Technical Note

Project No: ITS19302
Project Title: Land North of Handcross Road, Plummers Plan
Title: Stage 1 Road Safety Audit – GG119 Response Format
Ref: DS/OT/ITS19302-009
Date: 1 July 2025

**Stage 1 Road Safety Audit
J190512**

- 1.3 Following receipt of the RSA, additional drawings have been prepared that accompany this note, as follows:
 - ITS19302-GA-007 Rev A – Vehicle Swept Path Analysis

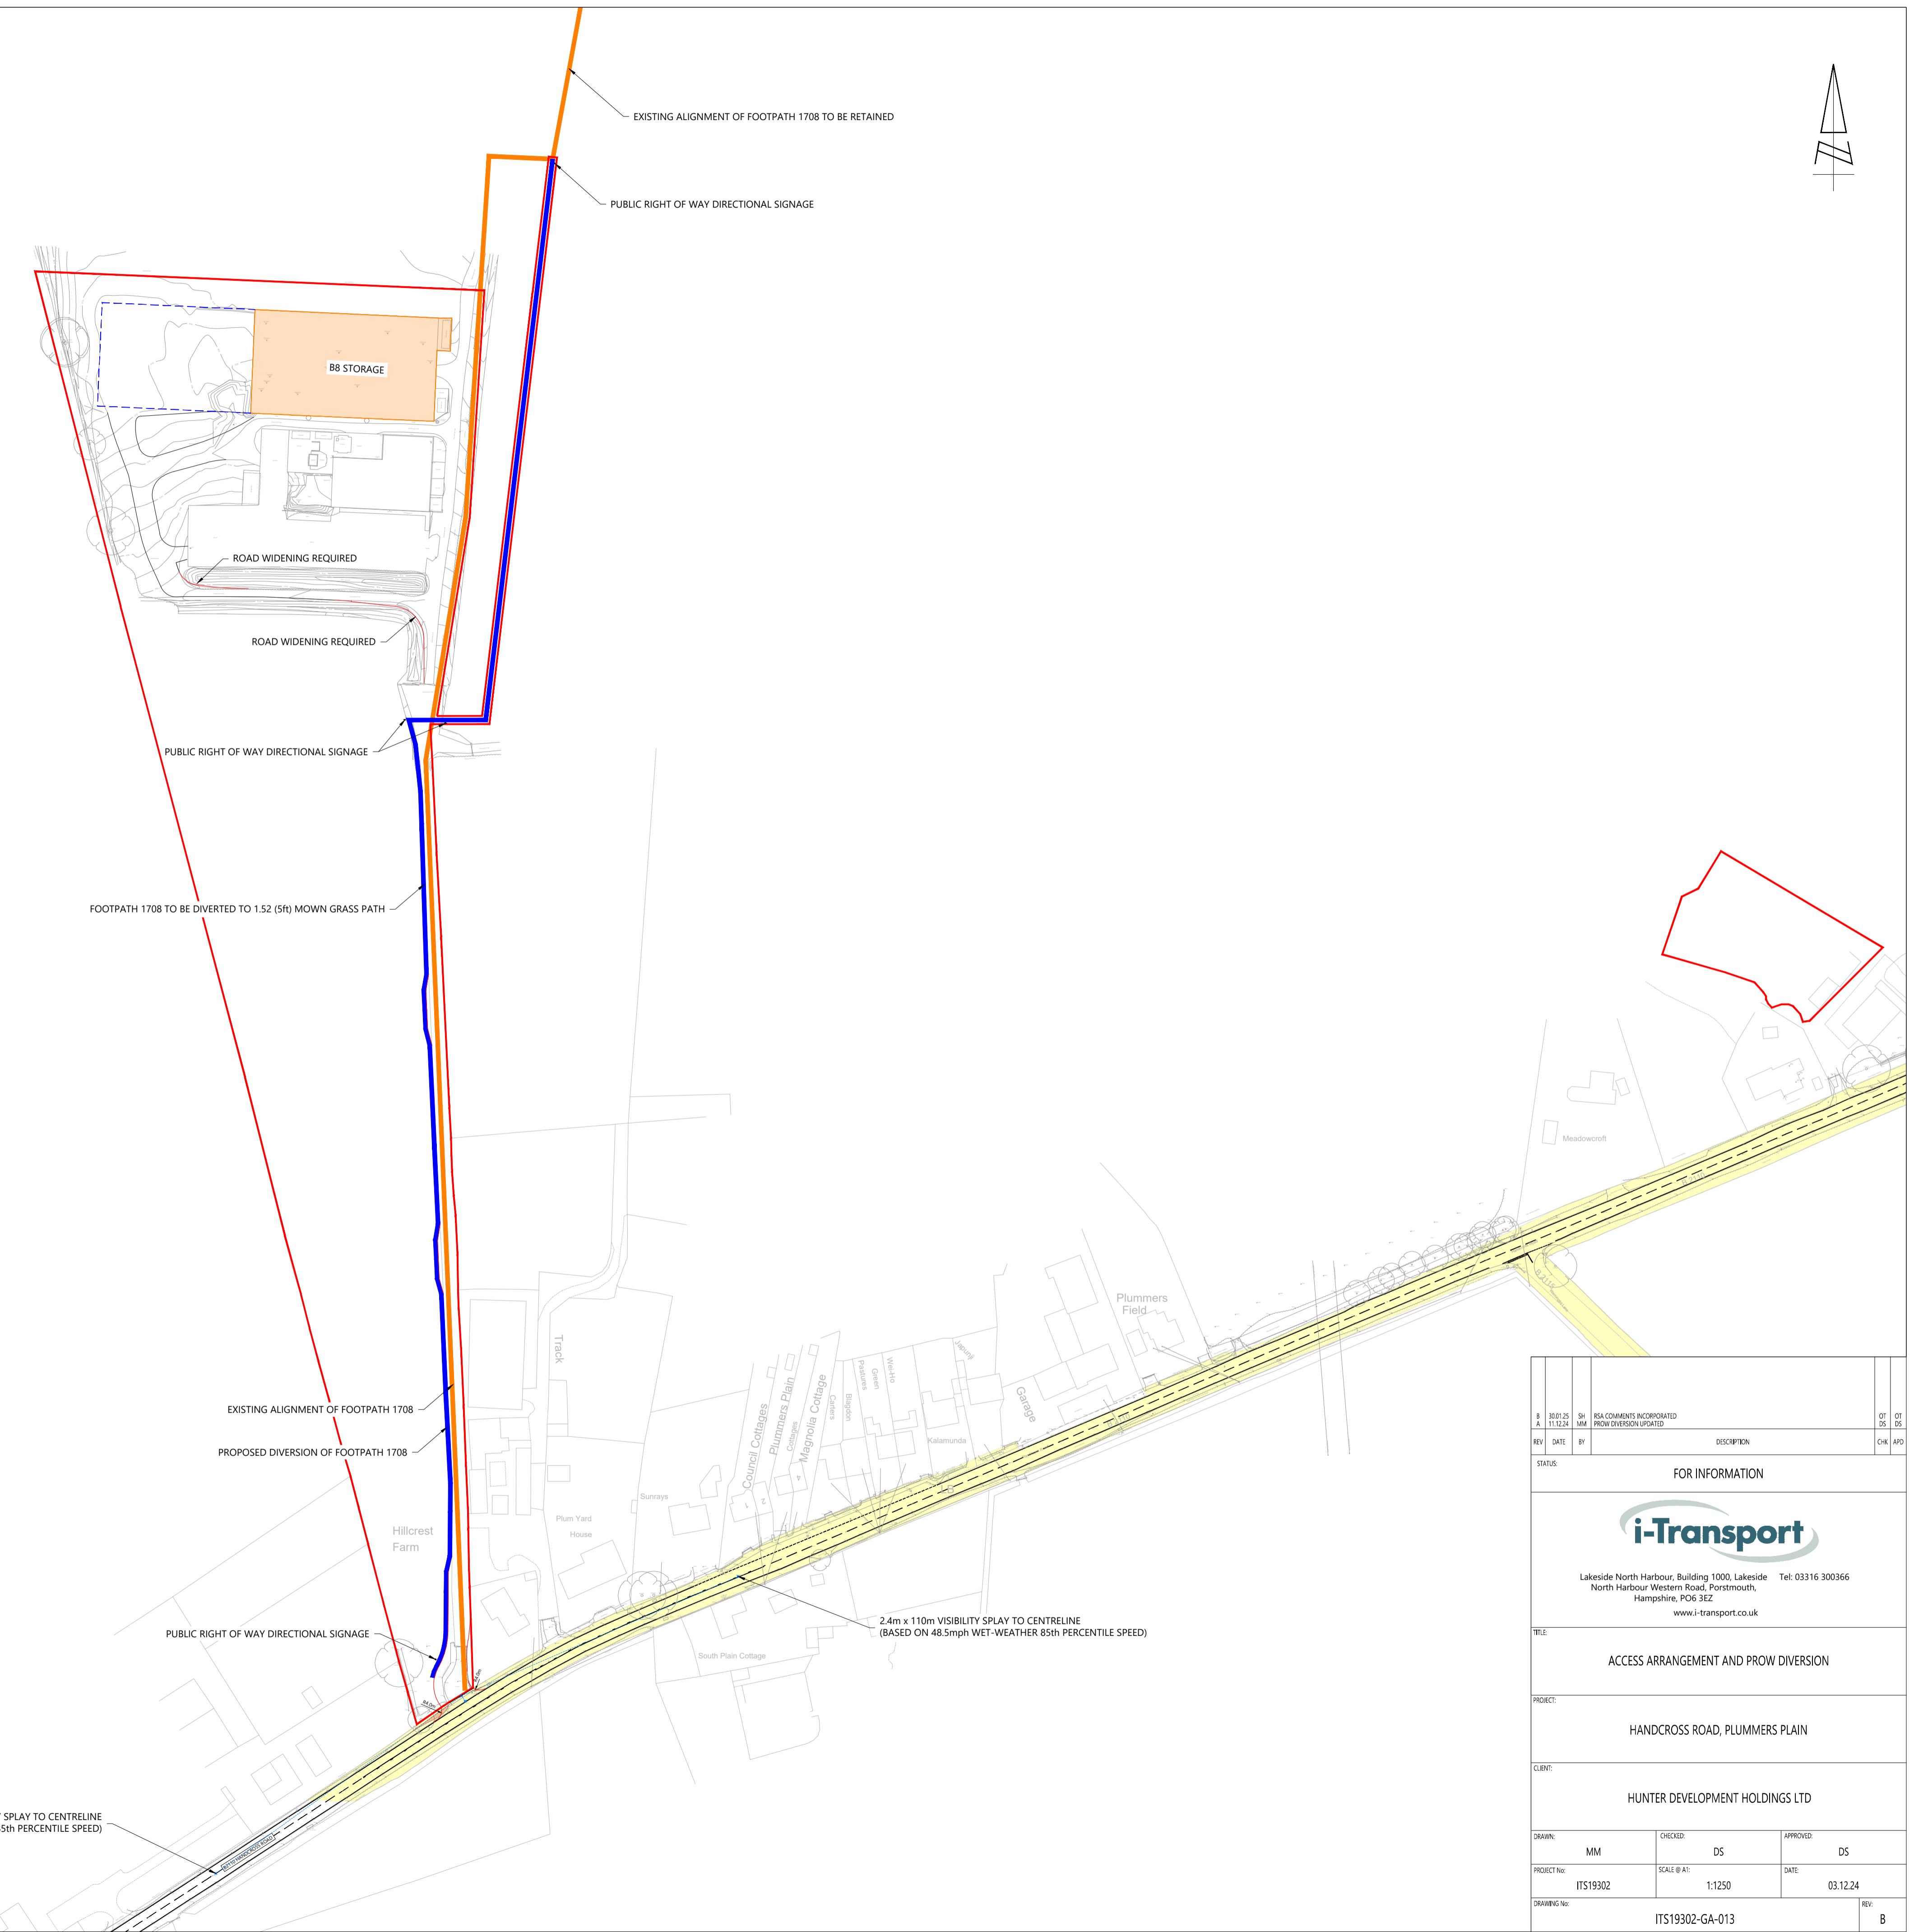
RSA Problem	RSA Recommendation	Design Organisation Response	Overseeing Organisation Response	Agreed RSA Action
<p>2. Risk of head on collisions: Swept path analysis has not been shown for all movements expected at the site access. Left-turning artics have not been demonstrated to be able to safely exit onto Handcross Road. This may cause site vehicles to encroach into the westbound lane, which may result in head-on or side-swipe collisions with passing traffic</p>	<p>Undertake swept path analysis for all expected vehicle movements</p>	<p>Accepted – Drawing ITS19302-GA-007A illustrates swept path analysis for all expected vehicle movements generated by the site.</p> <p>All movements can be undertaken without encroachment into the opposing lane (e.g. movements into the site), with the exception of the left turn out of the site access. It should be noted that this is an existing situation – the proposal can, and already does, generate large HGV manoeuvres. A detailed assessment of vehicular movements has been undertaken which demonstrates that pre and post-development movements are broadly comparable. The proposal includes improvement at the site access (e.g. widening and an increase in kerb radii) to enhance access for larger vehicles and provide a betterment to existing conditions.</p>

RSA Problem	RSA Recommendation	Design Organisation Response	Overseeing Organisation Response	Agreed RSA Action
<p>5. Risk of side swipe collisions: No swept path analysis provided to demonstrate that the largest expected vehicles can safely negotiate the passing areas and that the give-way lines are suitable. This may cause vehicles to wait at inappropriate positions, which may result in collisions.</p>	<p>Undertake swept path analysis for all passing areas.</p>	<p>Accepted - The design of the passing bays has been informed by swept path analysis for with reference to the expected movements as forecast using the TRICS database.</p> <p>The passing bays can accommodate the expected use without conflict, as shown in the extracts of an HGV & Large Panel van passing one another in both directions. With reference to Problem 3, the give way markings are to be removed from the scheme.</p>

- ITS19302-GA-013 Rev B – Site Access Arrangement

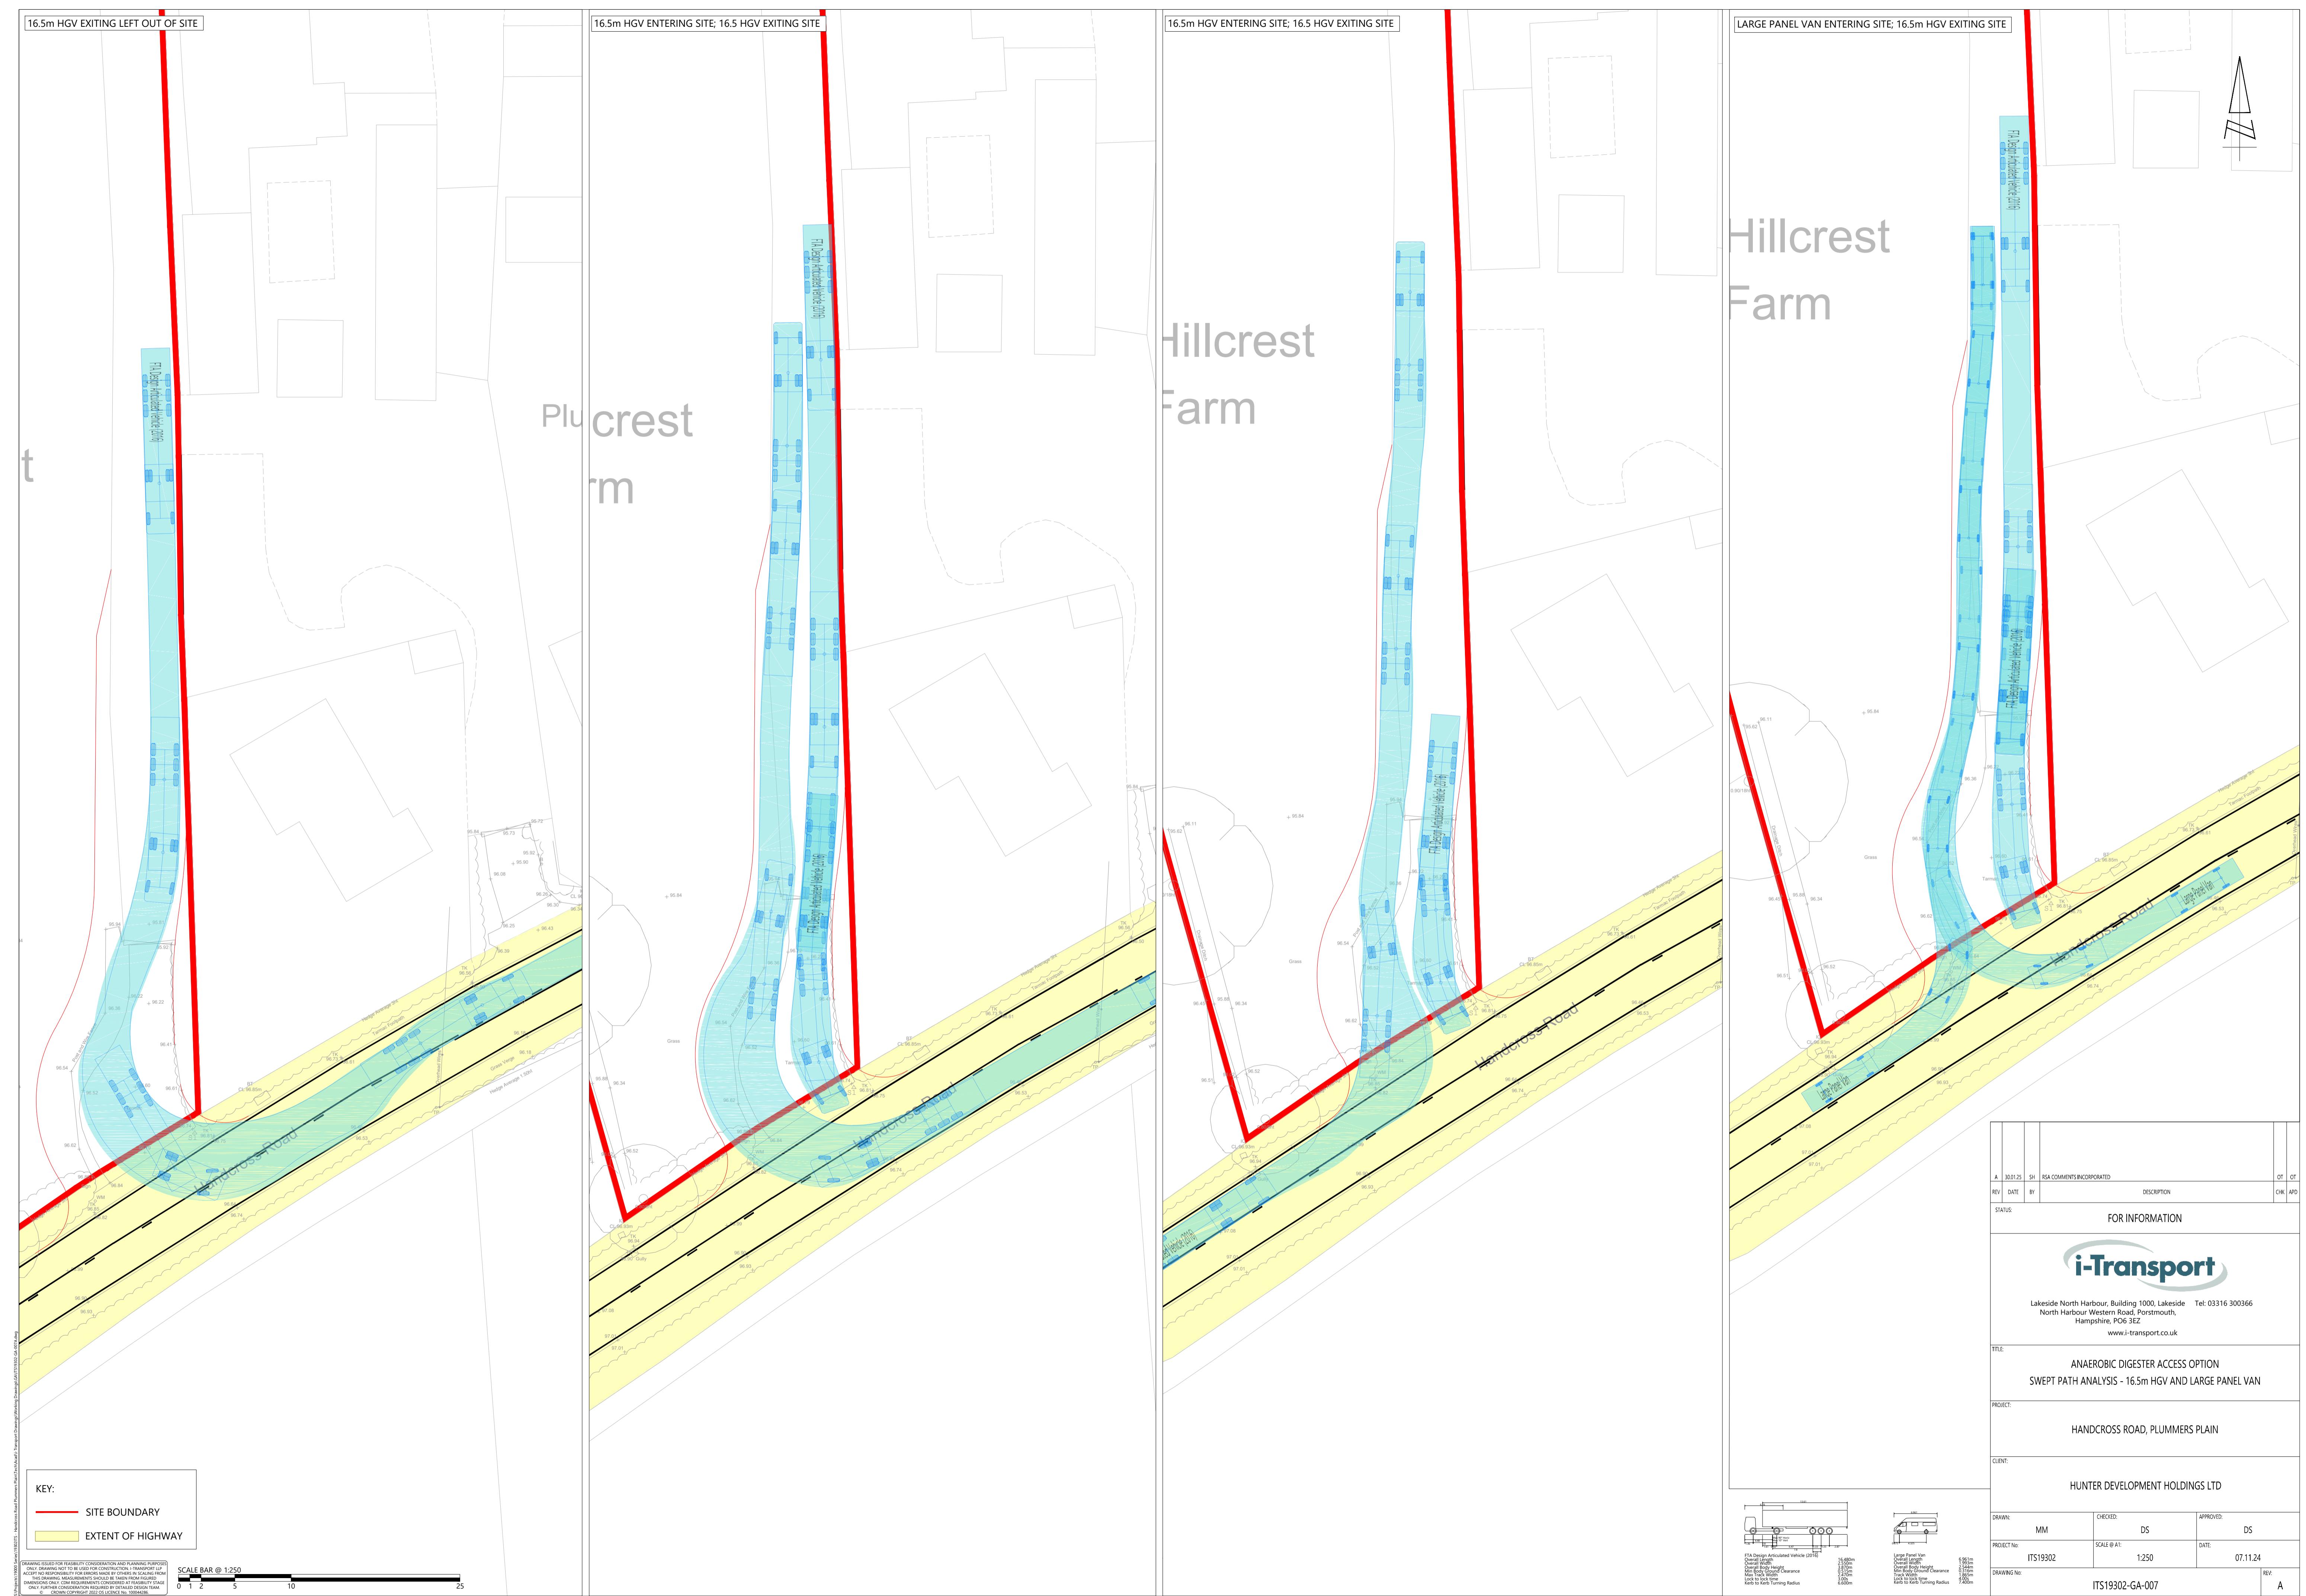
RSA Problem	RSA Recommendation	Design Organisation Response	Overseeing Organisation Response	Agreed RSA Action
<p>1. Risk of collisions with pedestrians: There are existing hedges directly adjacent to the site access. There are no proposals to provide pedestrian splays onto the footway from both sides of the amended access. This will cause an obstruction to pedestrian intervisibility, which may result in collisions with passing pedestrians</p>	<p>Provide appropriate pedestrian intervisibility from the site access.</p>	<p>Accepted – The hedgerow within the adopted highway boundary / the applicant's ownership will be trimmed back and maintained to ensure that a pedestrian to driver splay can be achieved.</p> <p>The access arrangement is existing with a minor increase in vehicle movements as a result of the proposal. The development will improve the current interaction between pedestrians and vehicles by maintaining the hedgerow. This is shown as an inset on drawing ITS19302-GA-013B.</p>

<p>3. Increased risk of rear-end shunts: The proposed internal give-way line is set back over 50 metres from the site access/ Handcross Road. This may cause slow moving exiting vehicles to encounter arriving vehicles after leaving the give-way position, resulting in confusion and the requirement for large vehicles to reverse back onto Handcross Road. This may result in collisions with passing vehicles.</p>	<p>Amend give-way position and associated widening.</p>	<p>Accepted - Drawing ITS19302-GA-13B has shown the removal of the give-way markings, although passing bays have been retained for use along the access road. In addition, further localised widening of the site access has been incorporated into the design to enable vehicles to pass at the access and prevent obstruction of Handcross Road and reversing manoeuvres back onto the road.</p>

RSA Problem	RSA Recommendation	Design Organisation Response	Overseeing Organisation Response	Agreed RSA Action
<p>4. Risk of vehicles overhanging onto the main road: The proposed layout includes widening a short section of the access road to accommodate large vehicle entering the site. Swept path analysis has not been provided to demonstrate that a right-turning artic (entering) can do so when another artic is waiting to exit the site. This may cause inappropriate carriageway area to be provided, which result in collisions between entering and exiting vehicles.</p>	<p>Amend access layout/arrangement to accommodate expected movements.</p>	<p>With reference to Problem 3, the site access arrangement has been amended to incorporate additional widening at the access. Drawing ITS19302-GA-007A illustrates swept path analysis for all expected vehicle movements generated by the site which demonstrates that a right-turning artic can enter the site whilst another vehicle waits to exit.</p> <p>With reference to the TS accompanying the planning application, the TRICS analysis demonstrates that a negligible number of two-way articulated vehicle movement is expected. Similarly, the identified operator of the site has confirmed that articulated vehicle access is only required infrequently – i.e. once per week.</p>
